COMMENTS WITH REGARDS TO THE PROPOSED AMENDED LAYOUT OF THE RICHARDS BAY COMBINED CYCLE (CCPP) POWER PLANT AND ASSOCIATED INFRASTRUCTURE NEAR RICHARDS BAY, KWAZULU-NATAL PROVINCE (REF NR: SE1655)

RE: COMMENTS WITH REGARDS TO THE AMENDED LAYOUT PROPOSED FOR THE RICHARDS BAY COMBINED CYCLE (CCPP) POWER PLANT AND ASSOCIATED INFRASTRUCTURE NEAR RICHARDS BAY, KWAZULU-NATAL PROVINCE (REF NR: SE1655)

PROPOSED RICHARDS BAY COMBINED CYCLE POWER PLANT (CCPP) PROJECT IN RICHARDS BAY, KWAZULU-NATAL PROVINCE - REVIEW OF VISUAL IMPLICATIONS OF PROPOSED LAYOUT AMENDMENTS DETAILED ON SITE LAYOUT DRAWING 0.103/00010 REV 2

**ADDENDUM TO THE QUANTITATIVE RISK
ASSESSMENT FOR THE PROPOSED RICHARDS
BAY COMBINED CYCLE POWER PLANT NEAR
RICHARDS BAY, KWAZULU-NATAL PROVINCE**

Figure 1: The extent of the wetland ecosystem on the project site in relation to the amended layout.

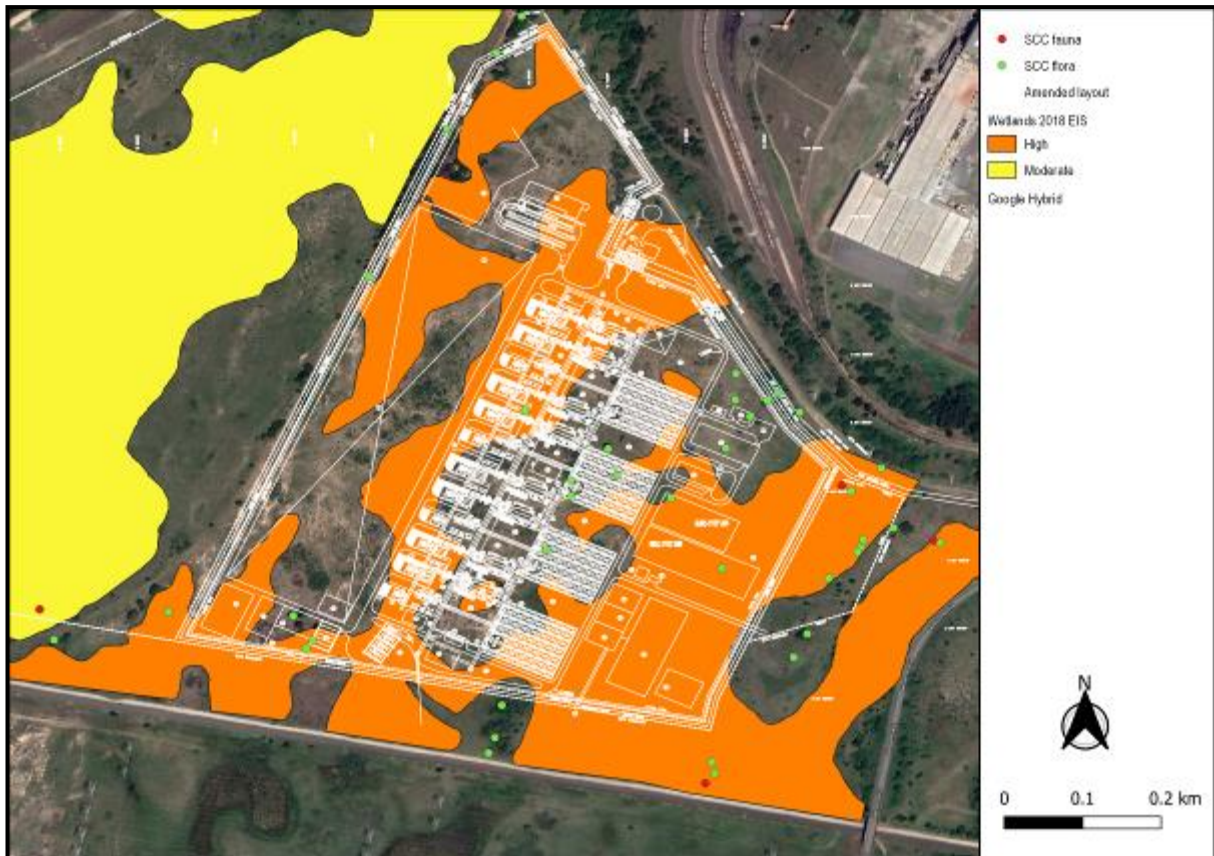
Due to the extent of the proposed project activities, the wetland ecosystems as delineated by 'The Biodiversity Company' and considered in the Ecological Impact Assessment Report covers large areas on the project site (Figure 1). Although it is conceded that the development footprint was reduced on the amended layout, drainage of the wetlands will still be required to accommodate infrastructure. Consequently the loss of wetland ecosystems will be unavoidable. Since the wetland ecosystem on the project site provide habitat to three wetland dependent fauna species of conservation significance, i.e. *Hemisus guttatus* (Vulnerable), *Crocidura mariquensis* (Near Threatened) and *Hyperolius microps* (Range Restricted), the implementation of the wetland offset plan as proposed in the Environmental Impact Assessment Report of March 2019 will still be relevant.

Figure 2: Tracks walked in the assessed project site as part of the Heritage Impact Assessment.

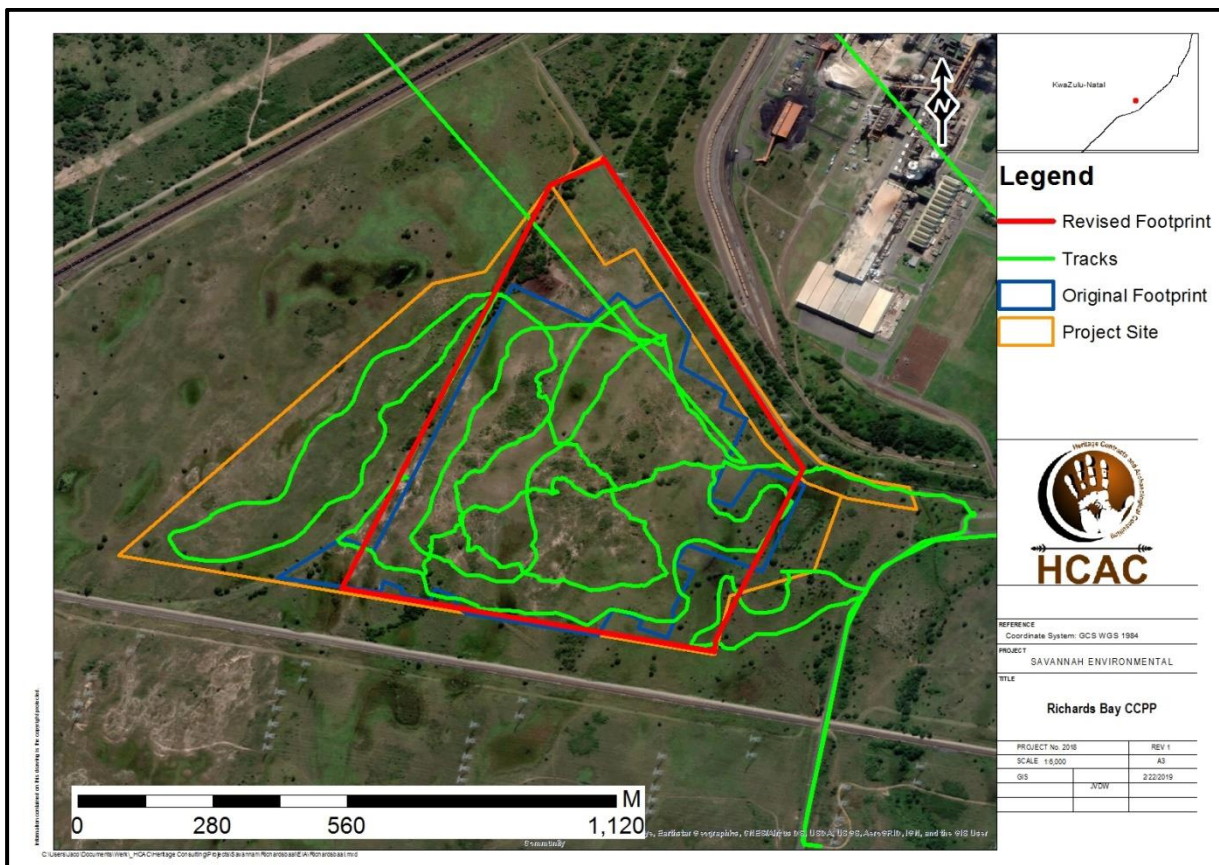
Figure 2 below illustrates the tracks walked as part of the Heritage Impact Assessment, which covered the project site.

The original layout assessed as part of the impact assessment report represented a development footprint of 71ha. The development footprint has been reduced to 52ha as part of the amended layout. Due to the lack of significant heritage resources in the project site the impact of the project on heritage resources is considered low. The amended layout does not have a material effect on the specialist report "Heritage Impact Assessment Richards Bay CCPP: 3000MW Feb 2019" and the findings and recommendations of the report still stand with the implementation of the amended layout. No additional mitigation measures are required with the implementation of the amended layout.

APPENDIX A – AMENDED LAYOUT

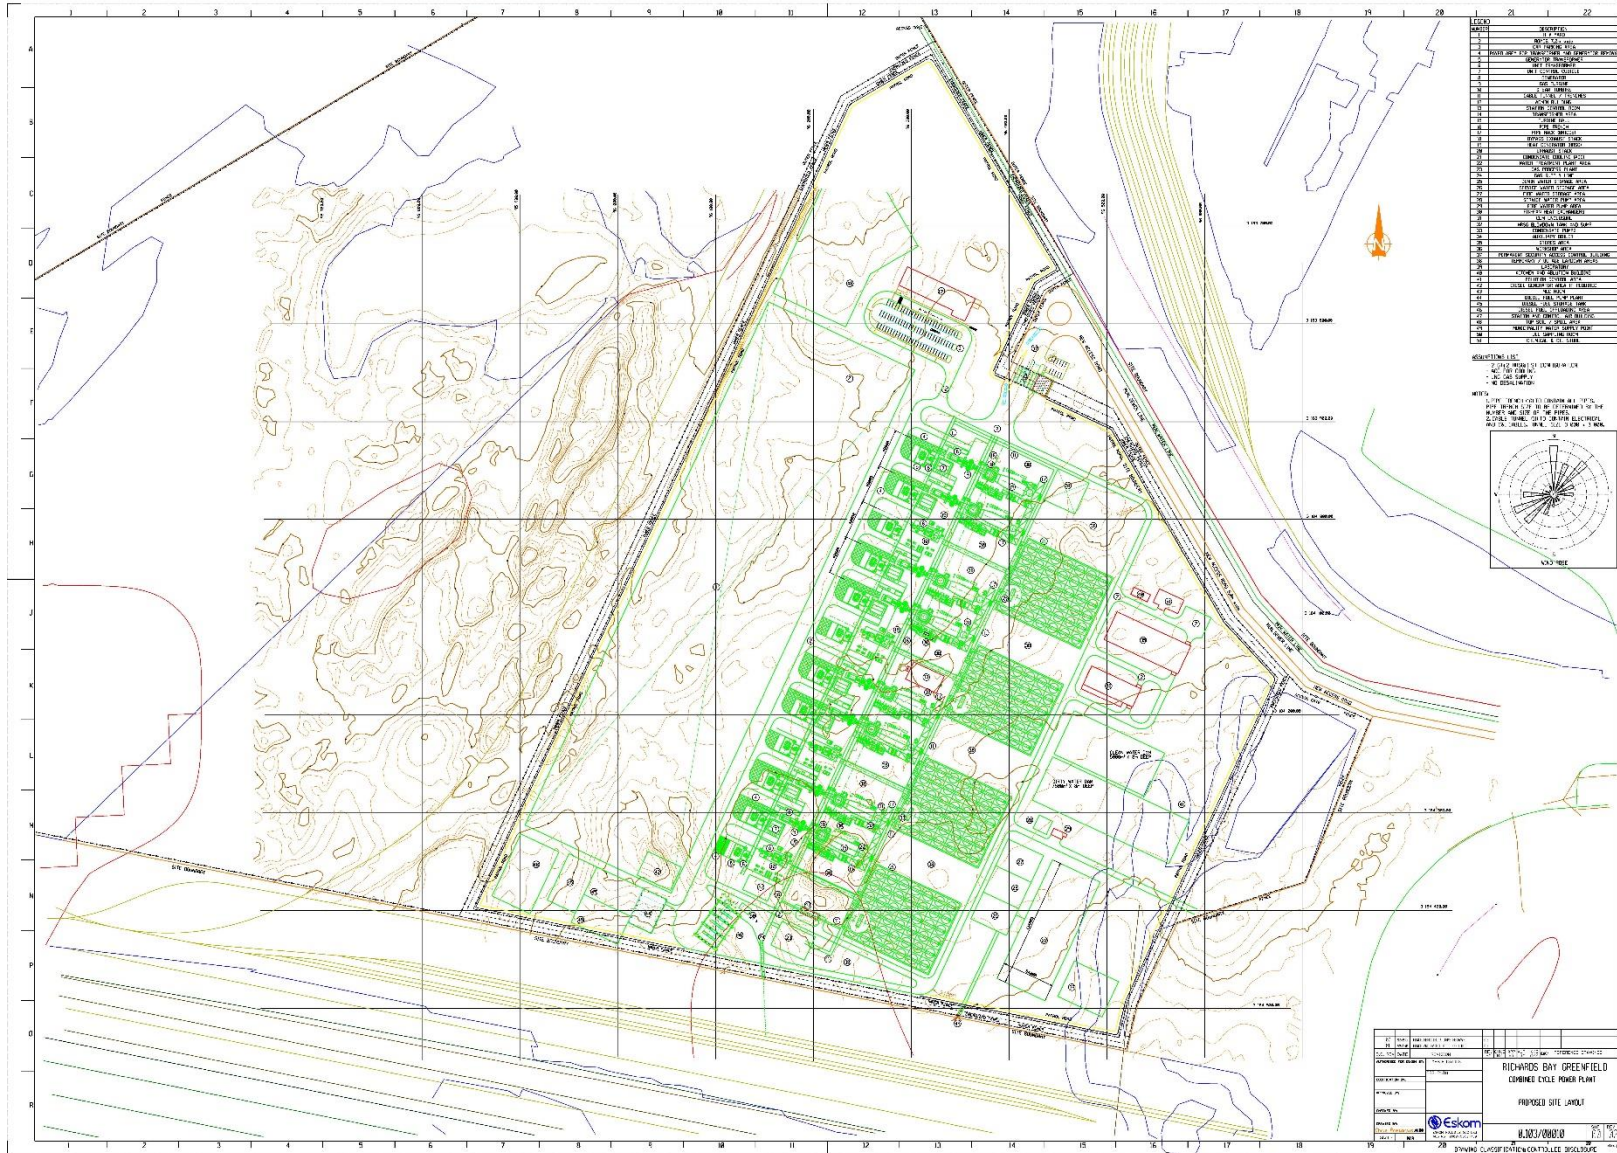
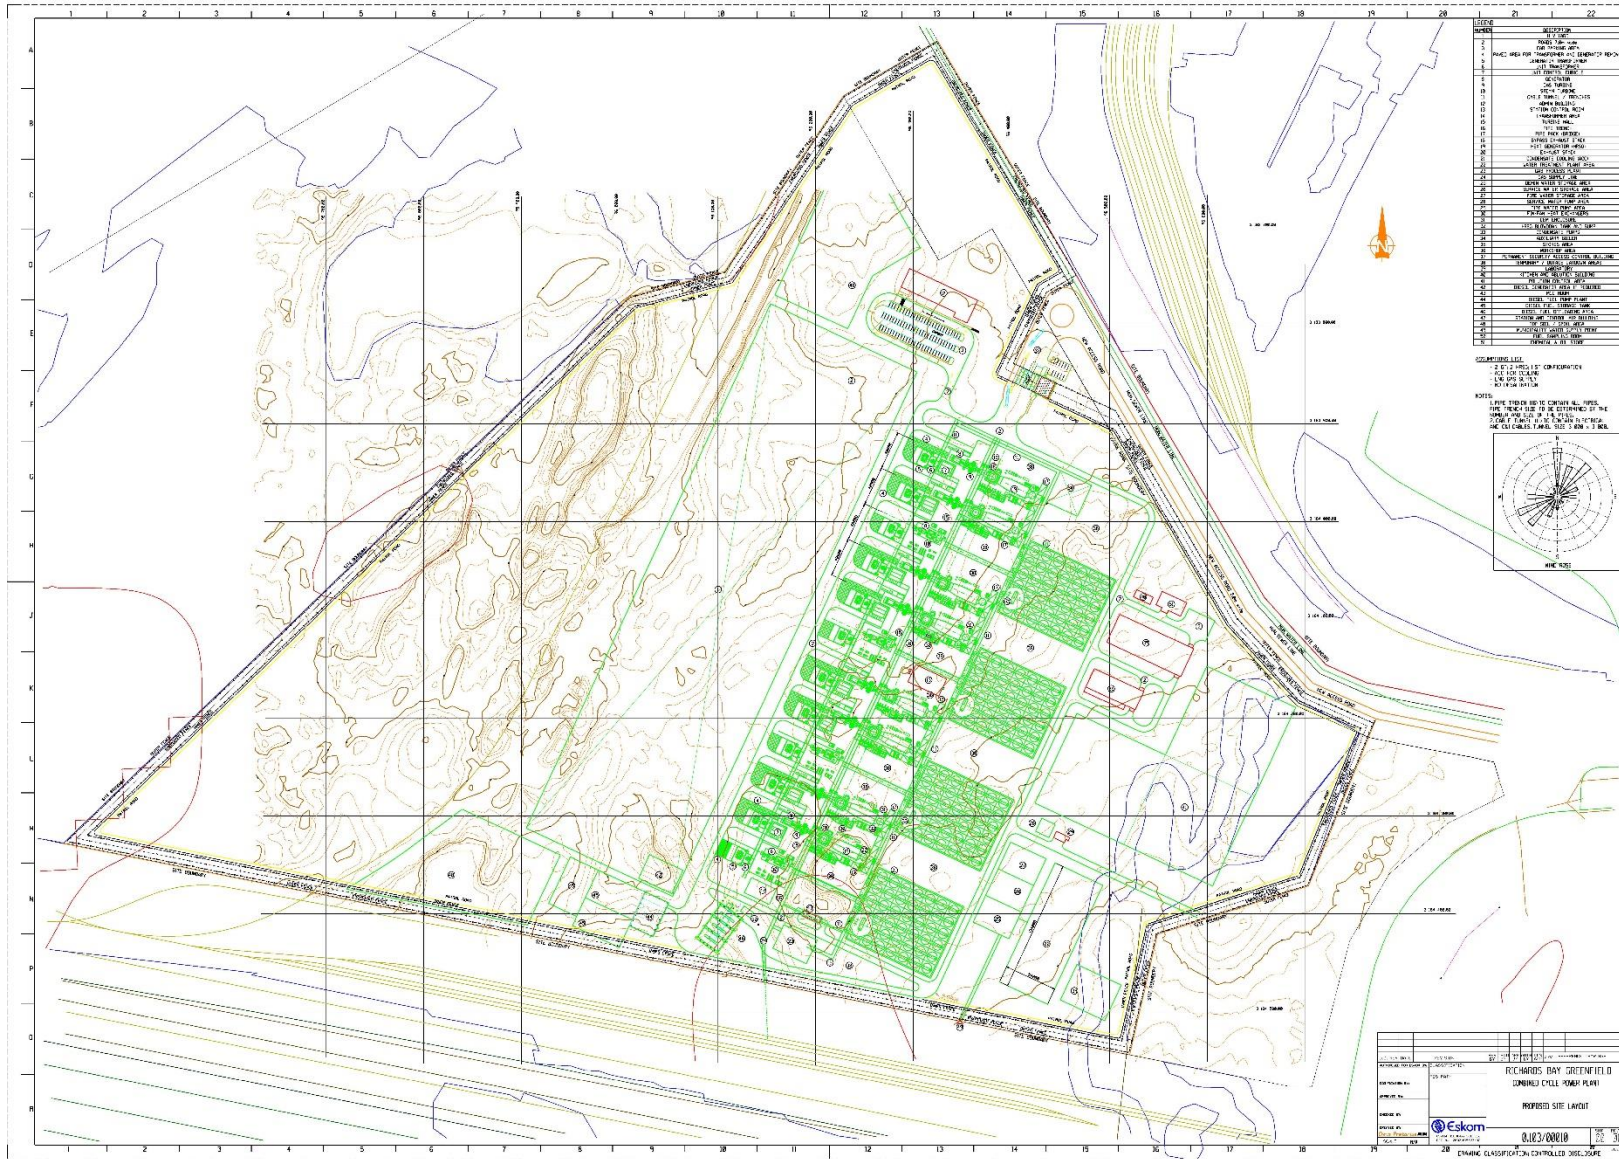
From the comparison of the originally assessed layout and the proposed amended layout, the location of major elements relative to each other remains consistent with the assessed layout considered as part of the Landscape and Visual Impact Assessment

Given the scale of the proposed development, the proposed amendments to the layout will not result in any change in the areas from which the proposed development is likely to be visible (Zone of Theoretical Visibility Map 7 of the Landscape and Visual Impact Assessment).

The amended layout will also not change the location or the extent of the view that the proposed development will occupy as indicated on Plates 15 to 24 inclusive within the Visual Assessment Report.

Figure 2 – May 2019 Amended layout for the CCPP.

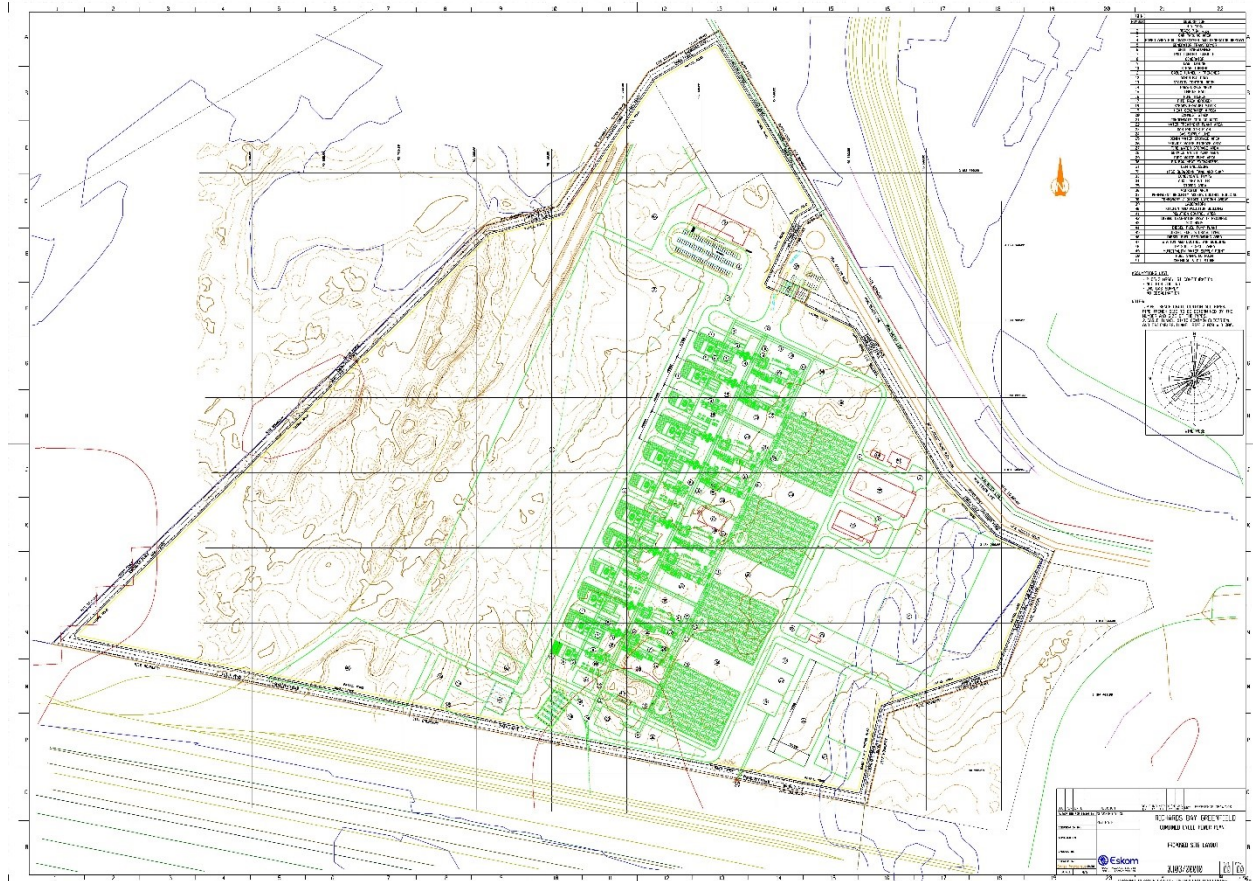
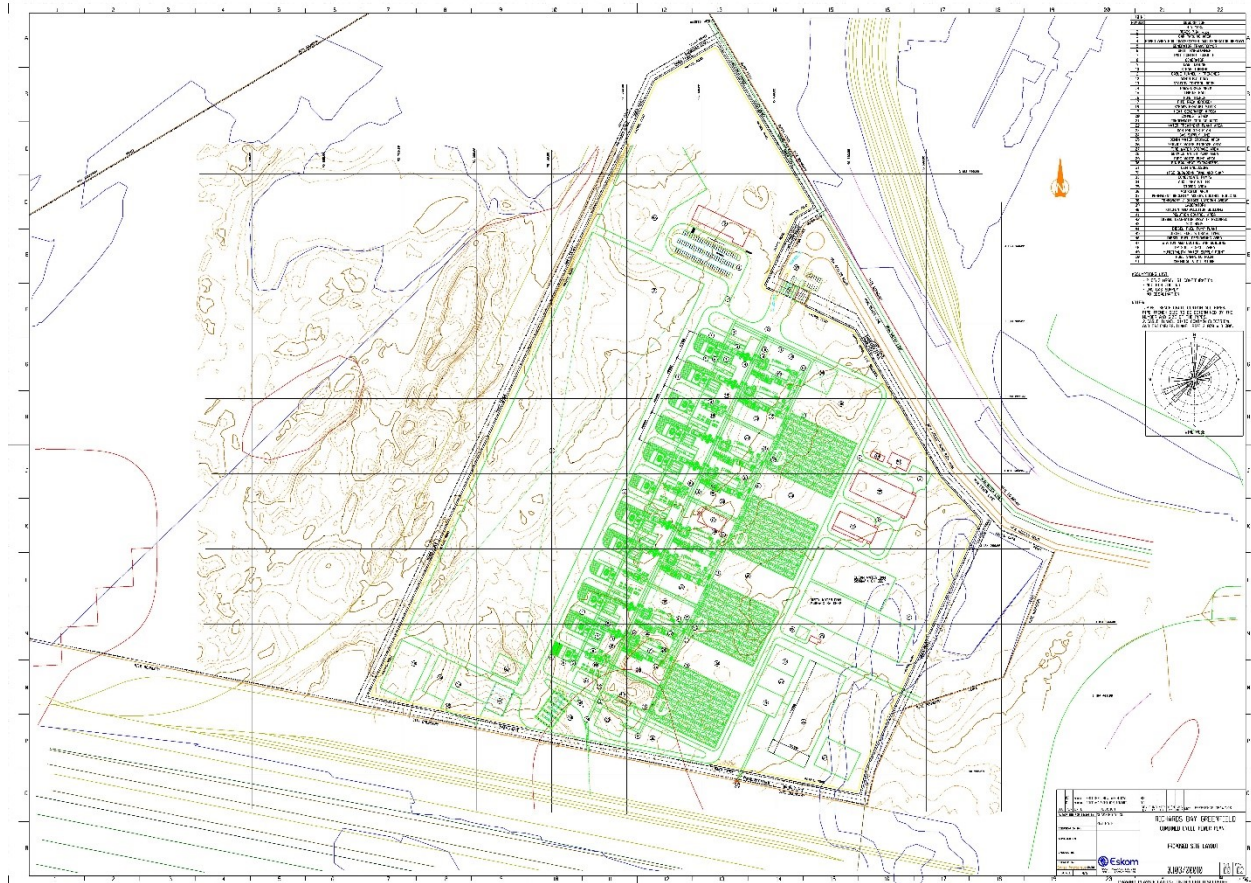
The proposed CCPP site boundary has since been amended (reduced in size) as shown in **Figure 2** below.

The change in the layout does not impact on the proposed CCPP, nor does it impact on the site access, expected traffic generation, and environmental assessment as contained in the Traffic Impact Assessment Report for the proposed CCPP Power Plant, Richards Bay, KwaZulu-Natal – February 2019 – Techso (Pty) Ltd.

1. The TIA Report dated February 2019 remains valid and that the amended layout, as shown in **Figure 2** of this report, has no impact on the conclusions and recommendations of the TIA dated February 2019.
2. The mitigation measures included are sufficient for the implementation of the amended layout and no additional measures are required.
